SUBJECT: Responds to 900322 request for addl info re 870817
 application to amend License DPR-23 on extending OL.

H. B. ROBINSON STEAM ELECTRIC PLANT, UNIT NO. 2

RESPONSE TO REQUEST FOR ADDITIONAL INFORMATION -
EXTENSION OF OPERATING LICENSE (TAC NO. 66079)

RESPONSE TO REQUEST FOR ADDITIONAL
INFORMATION FOR THE EXTENSION OF
THE OPERATING LICENSE FOR
H. B. ROBINSON STEAM ELECTRIC PLANT, UNIT 2

H.B. ROBINSON RADWASTE DATA

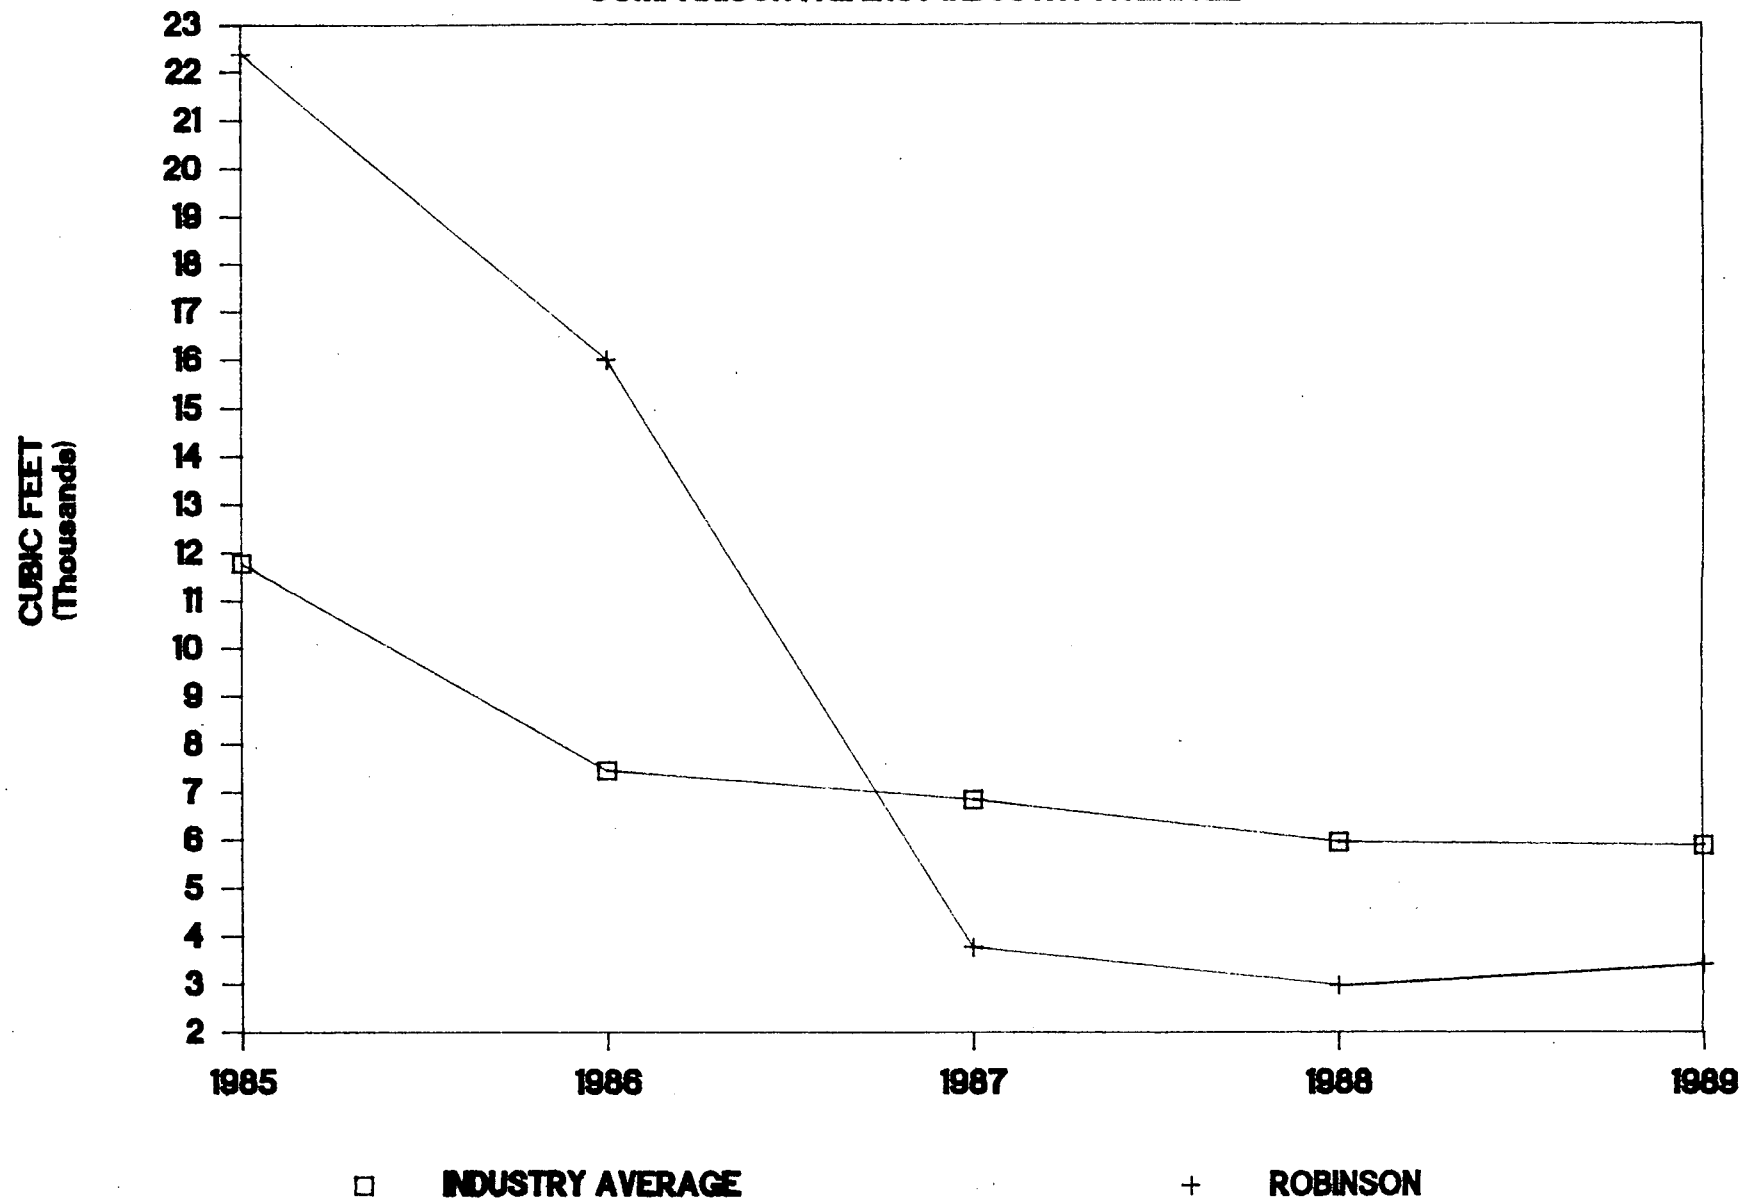
9. *Provide a comparison between actual radwaste shipments in recent years and the information provided in FES section 11.1.7, and estimate the impact for the extension periods.*

The FES for the H. B. Robinson Nuclear Project, Section 11.1.7, discusses the anticipated volumes of solid radioactive waste generation associated with the operation of the facility. The original projections estimated that approximately 500, 55 gallon drums of wet solid wastes (spent demineralizer resins, filter sludges, and evaporator bottoms) would be generated and shipped annually. In addition, approximately 450, 55 gallon drums of dry solid wastes (ventilation air filters, contaminated clothing, paper and miscellaneous other items) would be generated and shipped annually. This equates to a total of 950, 55 gallon drums or approximately 7125 ft³. Currently, the facility no longer generates liquid concentrates and has switched to an in line demineralization system for radwaste processing in an effort to minimize solid radwaste generation.

During the past five years of operation the facility has made tremendous progress in reduction of radwaste volume. While the facility's solid radwaste volume had at one time been greater than projected by the FES (partially due to solid wastes generated as part of the steam generator replacement outage), it has been reduced well below this value and has also been well below the industry average as defined by the Institute for Nuclear Power Operations (INPO). Table 9.1 provides the total solid radwaste volume in cubic feet produced per year for the past five years of operation along with the industry average for PWR's for the past five years. As shown in this table, the H. B. Robinson Nuclear Project has been well below the industry average for the past three years. Based on the volume produced to date this year, it is expected that 1990's radwaste volume will also be well below the industry average. CP&L is continuing to actively pursue additional volume reduction techniques such as incineration of dry active wastes and resin oxidation. In addition, CP&L is also pursuing source term reduction techniques such as cobalt elimination which, in addition to volume reduction, will likely produce a reduction in radwaste activity.

Based on this information, it is expected that annual average waste volumes will continue to remain below the original projections of the FES and that solid radwaste production of the facility will continue to be reduced as new technologies become available. The expected solid radwaste generation for the years of requested license extension will be a small fraction of the total generated over the facilities lifetime. This volume is not considered to be significant and will not alter the conclusions of the FSAR or the FES.
